FENCE PERMIT

NO. 25-06
ZONING DISTRICT R-2
FLOOD PLAIN: YES ☒ NO ☒ AG

This Fence Permit is hereby issued to Summer Ball
(Name)
421 2nd Ave Sw Phone # 563 608 3502 in accordance with
(Address)

Notes Fence Permit 25-06 submitted for your review.

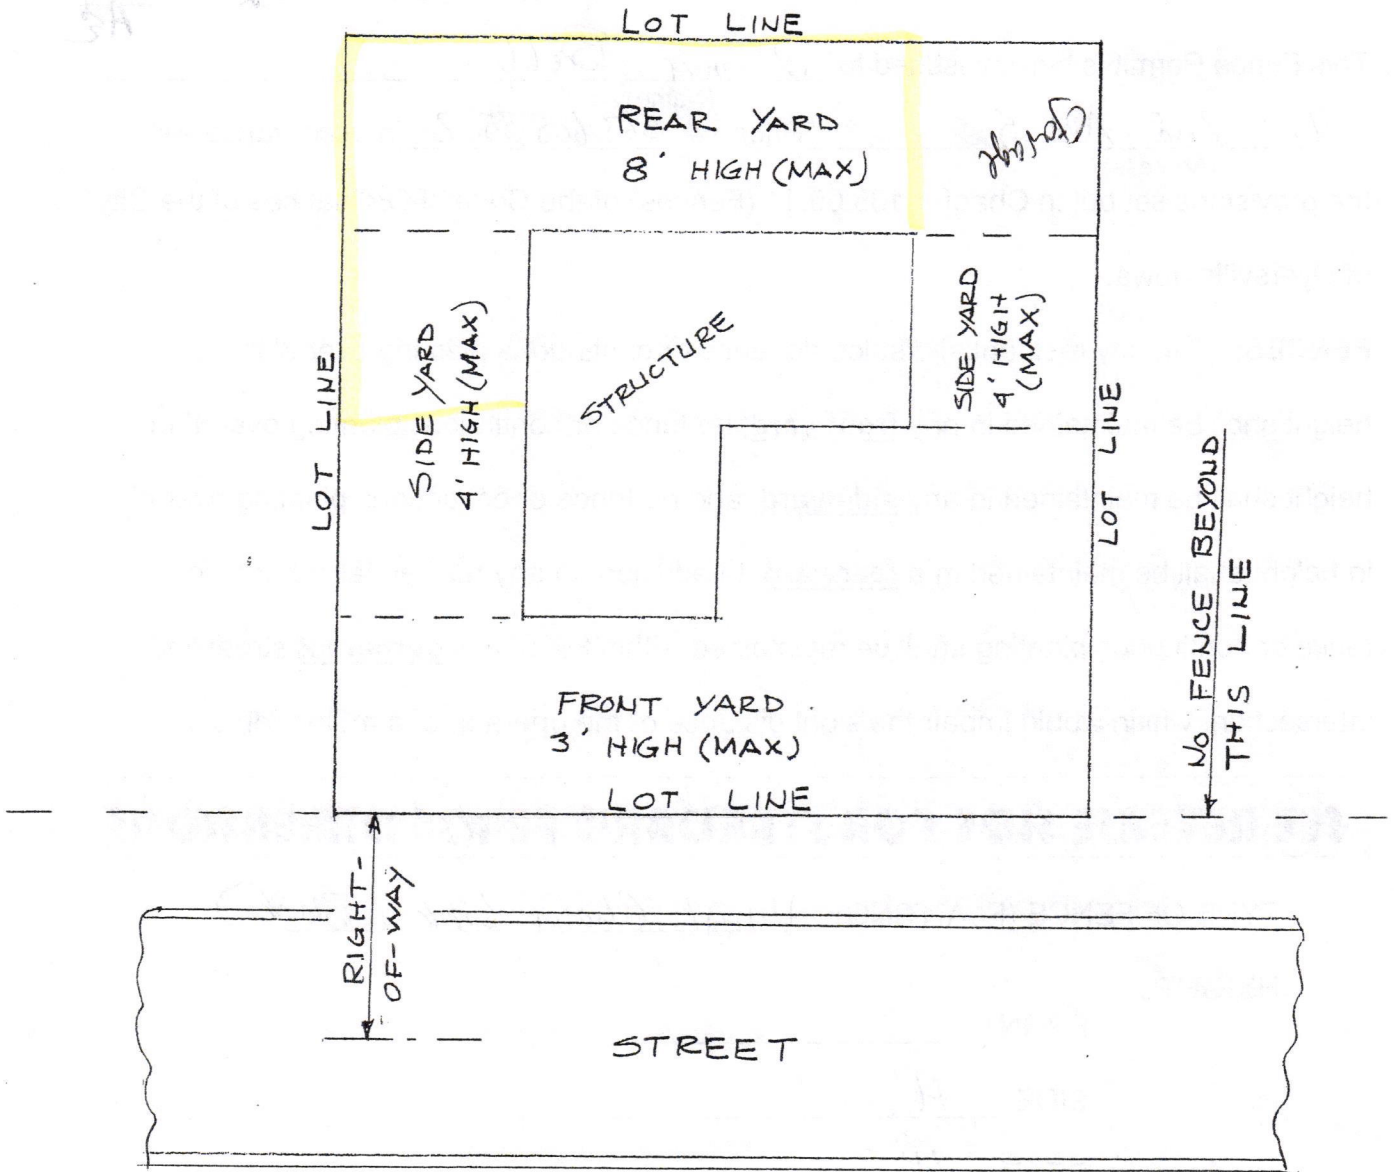
Entry Date	Employee	Log Entry
4/10/2025	Michel	I reviewed fence permit 25-06 and Section 165.09.11. The fence meets the minimum requirements. However, since the property is located within the flood fringe area, an approved permit from the city council is required. The property owner must obtain a floodplain development permit.
